Location Address: 1914-1920 Pierce Street

**SUBJECT:** Preliminary Site Plan and Design review for 32 Residential Units.

NEW 32 UNITS DEVELOPMENT AT  
**DOWNTOWN HOLLYWOOD**  
 1914 - 1920 PIERCE STREET HOLLYWOOD, FLORIDA 33020  
 (RESPONSE TO TAC COMMENTS DATED MARCH 20, 2023)

SHEET 1 OF 2

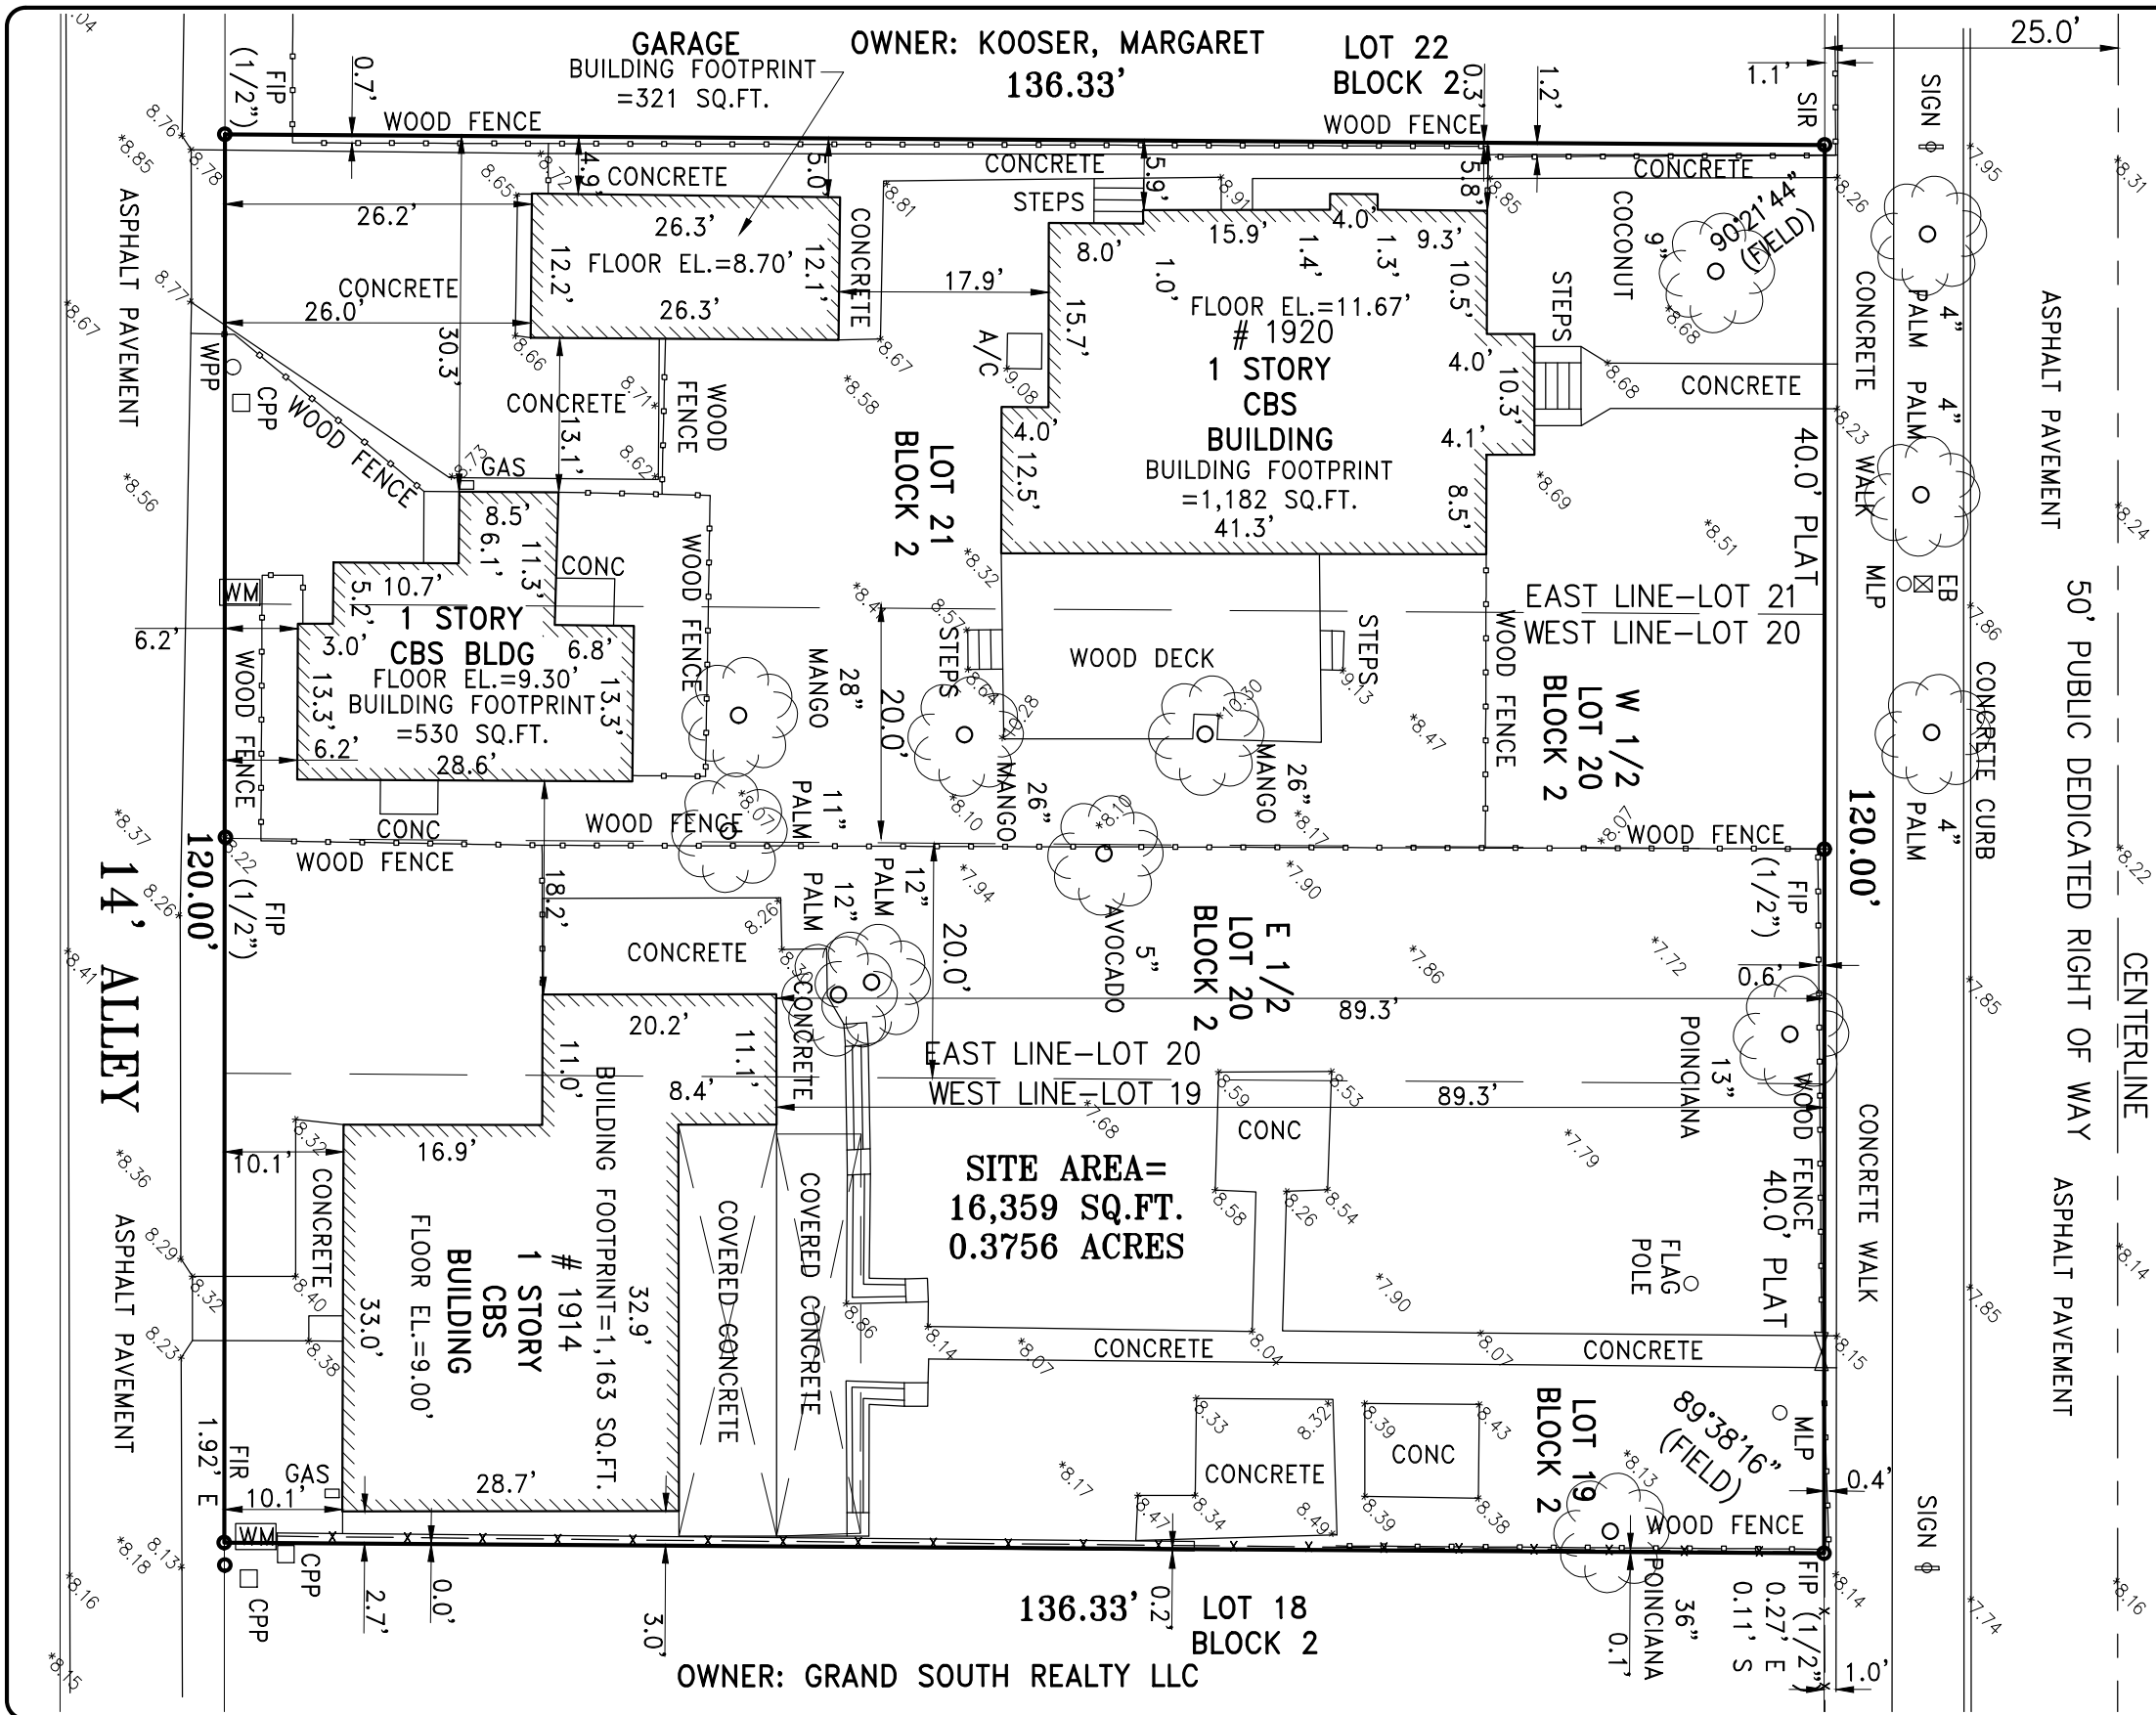
3. Alta Survey:
  - a. Shall be based on and dated after O&E. Ensure that O&E report is specifically referenced.  
**Please see updated survey based on O&E and stated such on sheet 1 of 2 on April 14, 2023.**

SHEET NO. **A100**  
2 of 8

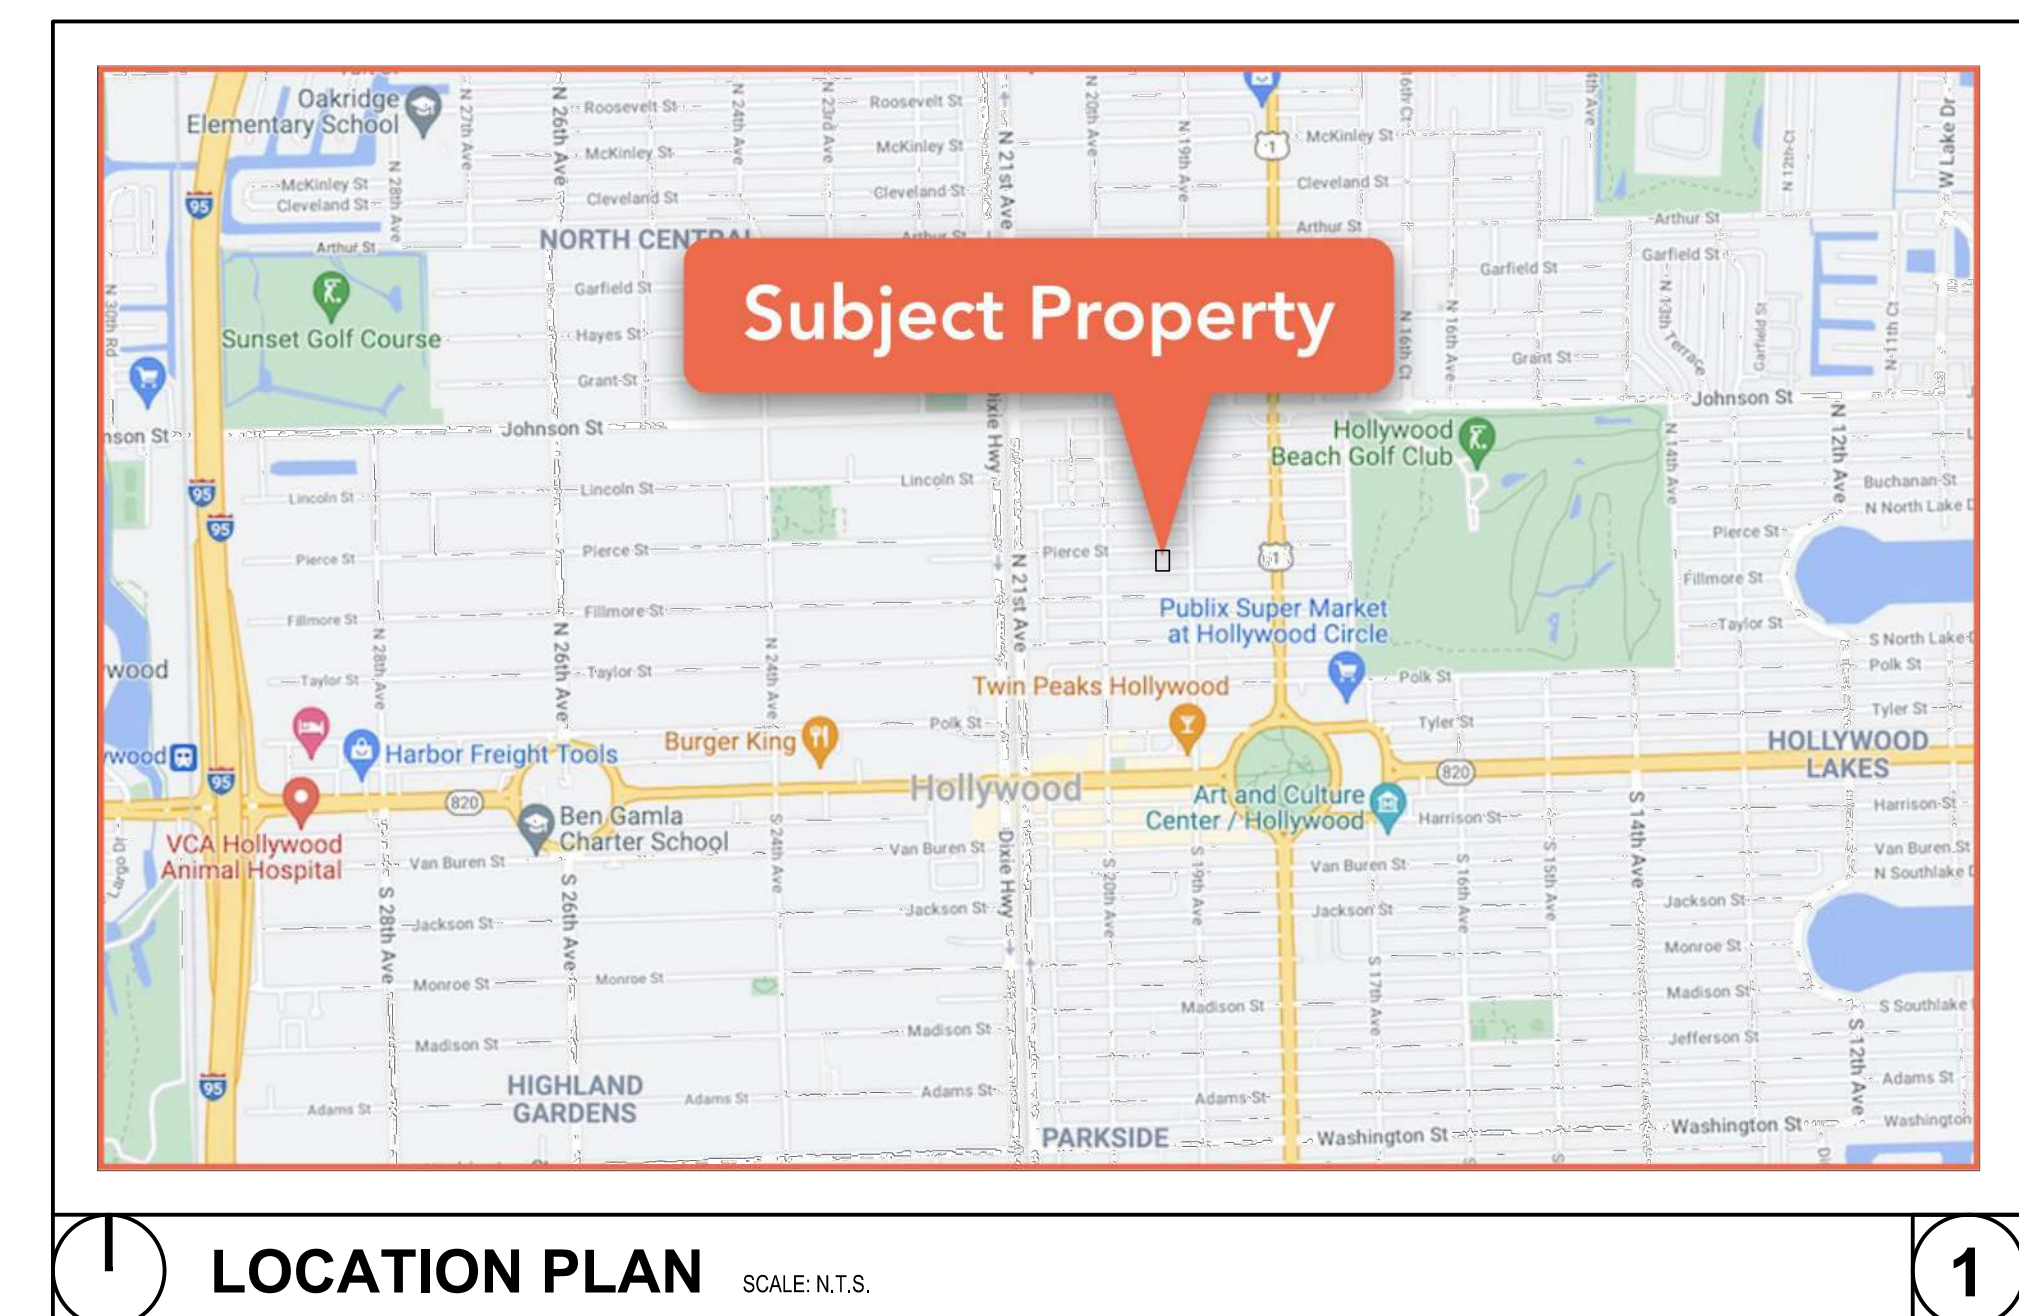
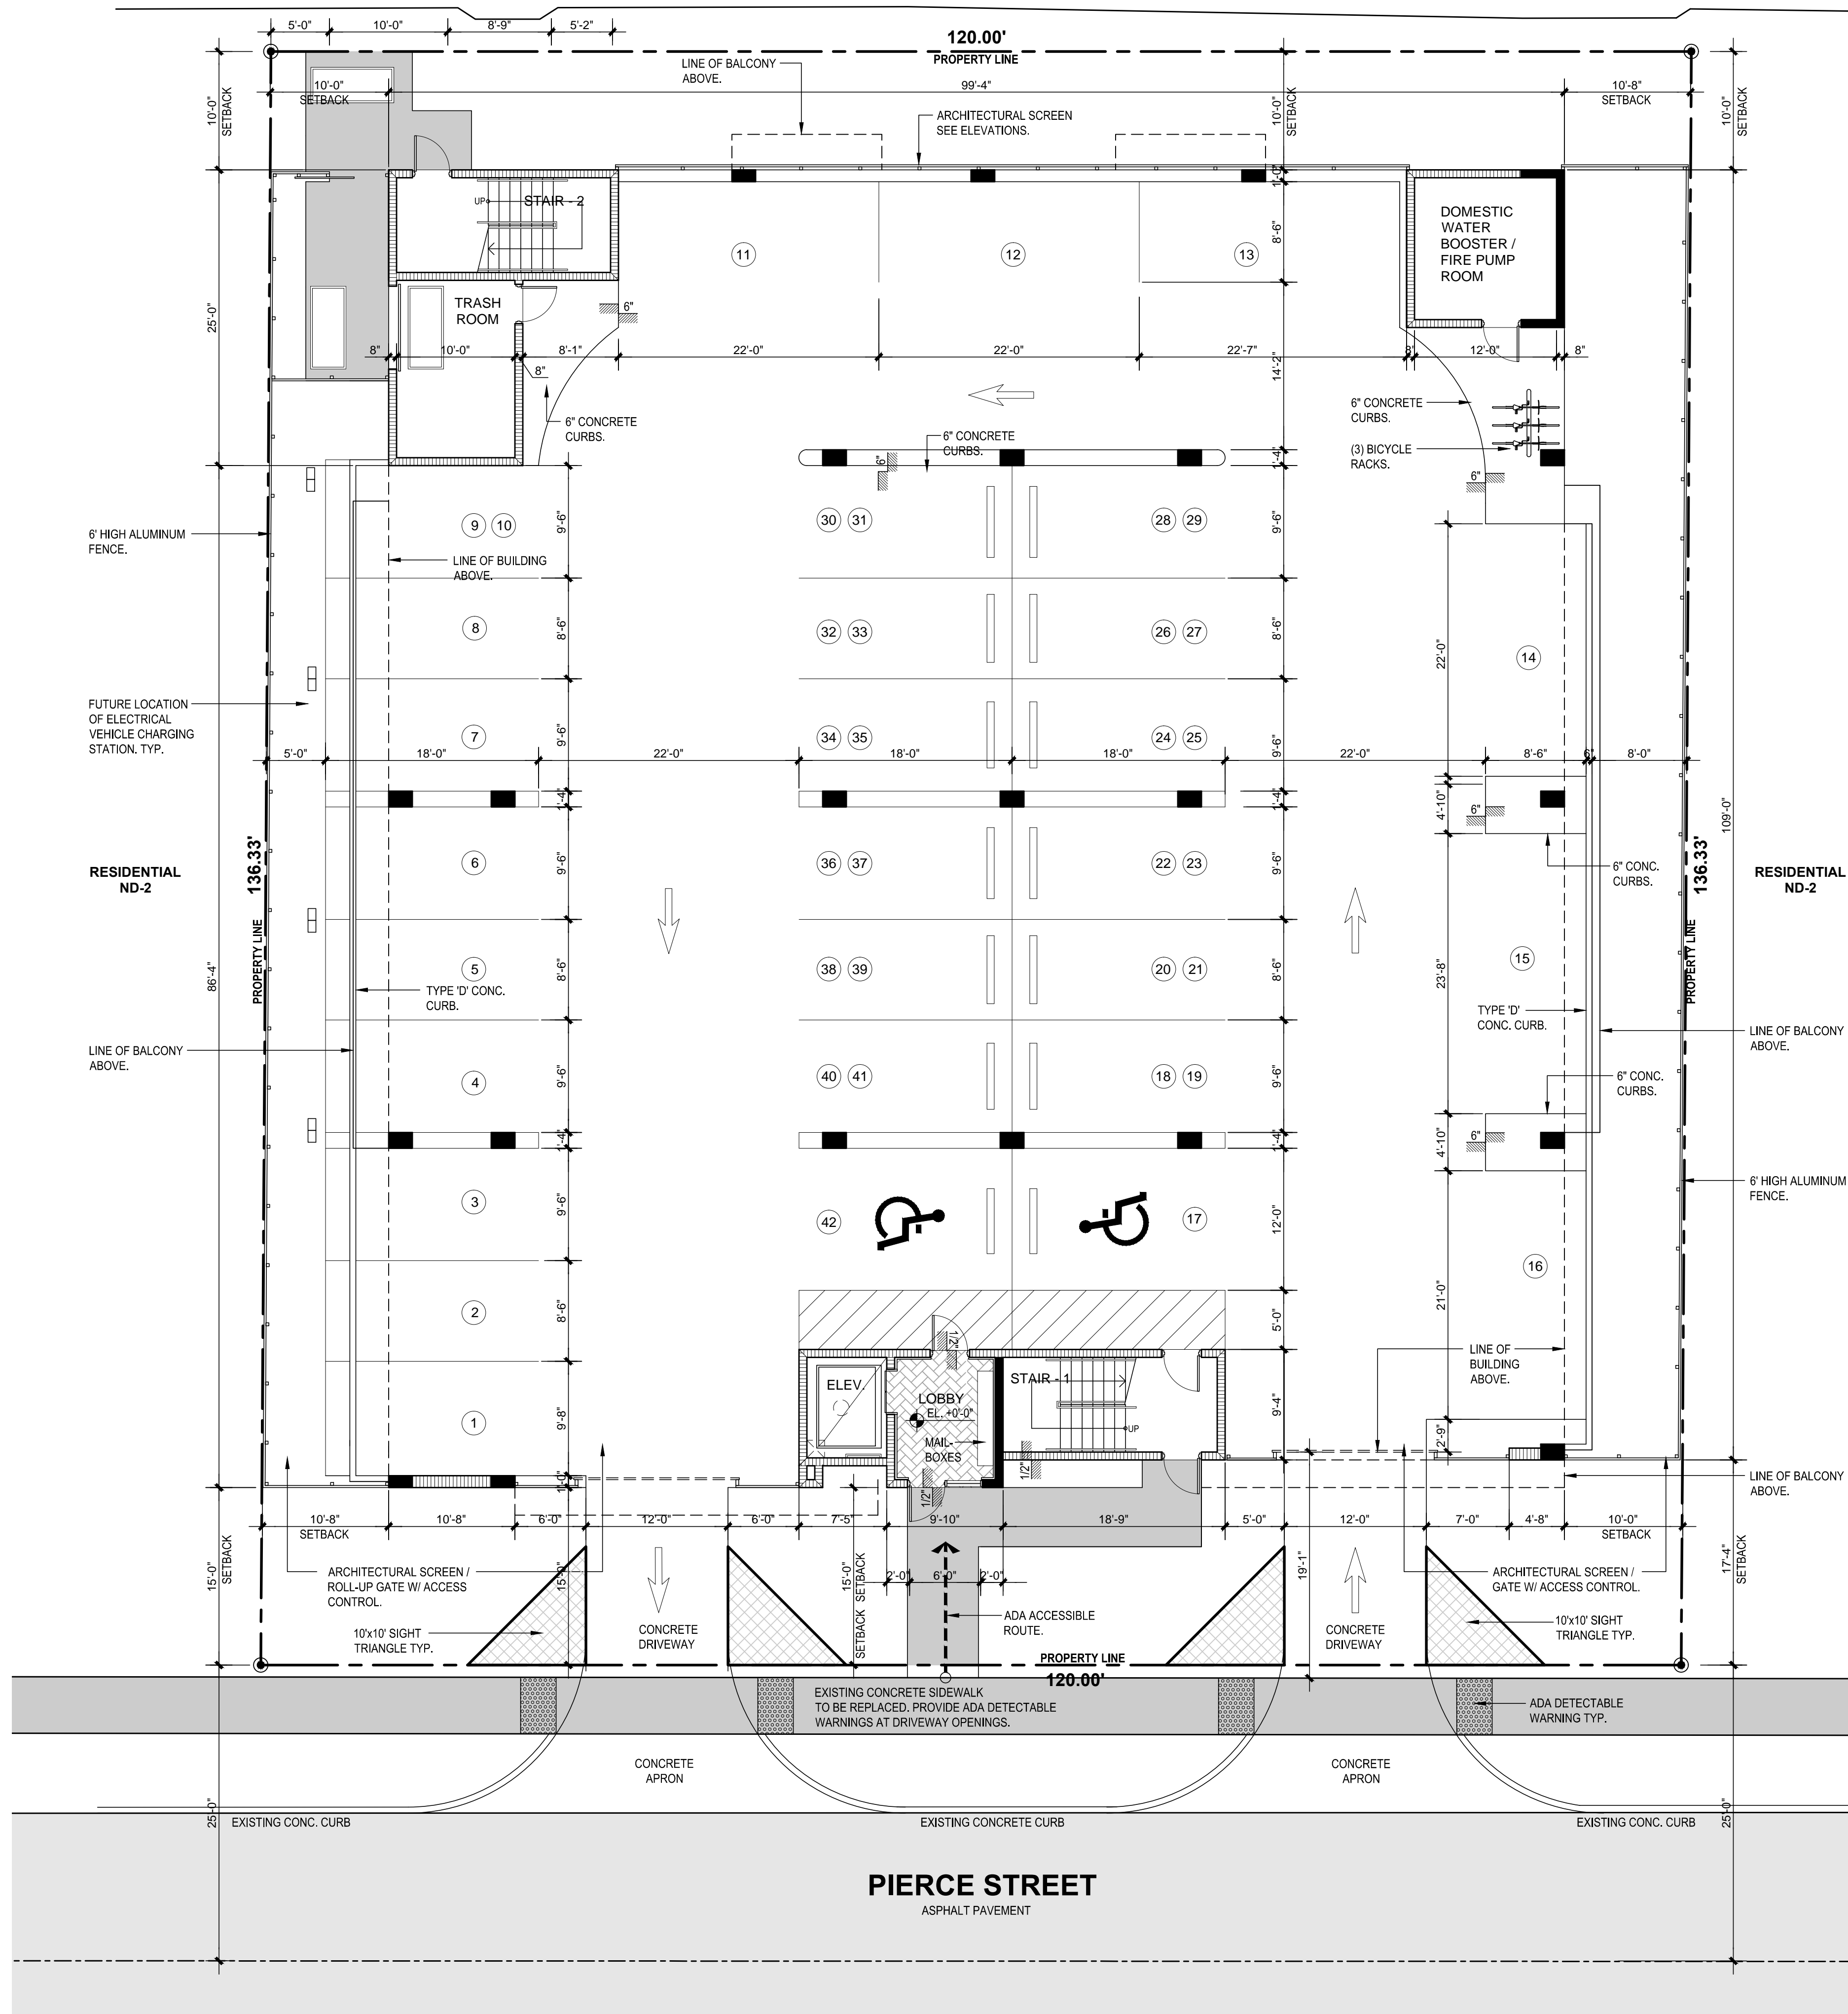
- b. Side setback should be measured at the exterior most portion of the building.  
**Response: Refer to Revised Drawings for setbacks location.**
  - c. Clearly show dimensions for both curb cuts that is labeled 24'. It appears the dimensions exceed the width indicated and 30% curb cut requirement.

**Response: Refer to Revised Site Plan A100**
  - d. Show dimensions for parallel spaces.  
**Response: Refer to Revised Site Plan A100**
  - e. Provide bicycle racks or storage shall. 1 per 20 spaces required.

**Response: Refer to Revised Site Plan A100**
  - f. No column shall be within 3 ft. of the entrance to a parking space. Show length dimension of driveways. Indicate on site plan.

- e. Label property line around all sides of site.  
**Response: Refer to Revised Site Plan A100**
  - f. Provide dimensions of all parking stalls, width and length. Stalls adjacent to obstruction on one side shall be minimum 9.5' wide and 10.5' wide for stalls with obstruction on both sides.

**Response: Refer to Revised Site Plan A100**
  - g. Provide dimension of drive aisle width adjacent to parallel Stalls 11-13 and indicate direction of vehicular traffic.

6. On Sheet A100, please clearly show where the building walls end adjacent to Stall 1 and Stall 16 and how the building accesses connect to the driveways. Also, please indicate material of the driveways and driveway aprons.

**Response: Refer to Revised Site Plan A100**
7. On Sheet A100, in the General Zoning Requirements Table, include the ADA stall in the parking calculations.

**Response: Refer to Revised Site Plan A100**
8. On Sheet A100, show the direction of vehicular traffic circulation on plan.  
**Response: Refer to Revised Site Plan A100**

15. Sheet A100, what is the double line running through parking Stall 1-10?

**Response: Refer to Revised Site Plan A100**
5. Provide width dimension for the parallel parking, minimum is 8.5'.  
**Response: Refer to Revised Site Plan A100**

**Response: Refer to Revised Site Plan A100**
